Staff Report – November 4th & 10th, 2020

COMMISSION MEETING DATE: November 4th and 10th, 2020 **APPLICATIONS:** DISTRICT **HISTORIC**

553-559 ISLINGTON ST. (LU-20-180) **CERTIFICATE OF APPROVAL PUBLIC HEARING #A**

East elevation showing rear addition

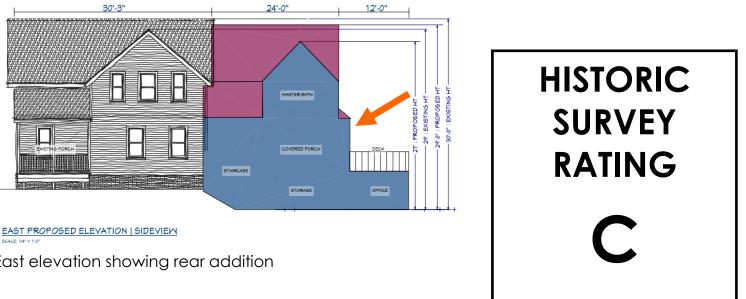
- Construct a rear addition with a deck and patio; and
- Renovate the existing structure with new siding, windows and roofing.
- - addition appeared sub-ordinate to the historic structure.

• At the last HDC meeting the Commission suggested the massing was much better as the

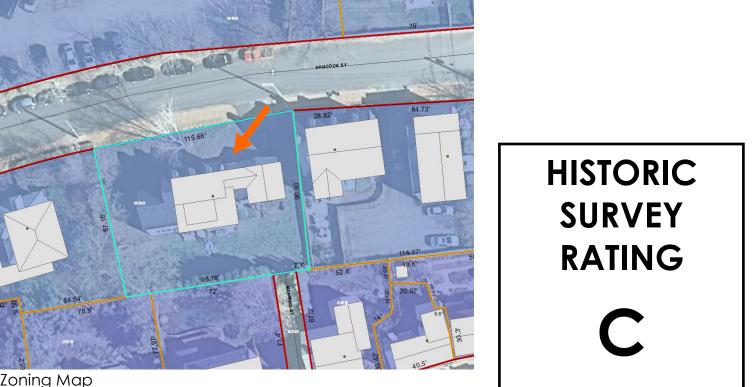
- Add a second floor to the garage.
- Add a second floor connector between the garage and house.
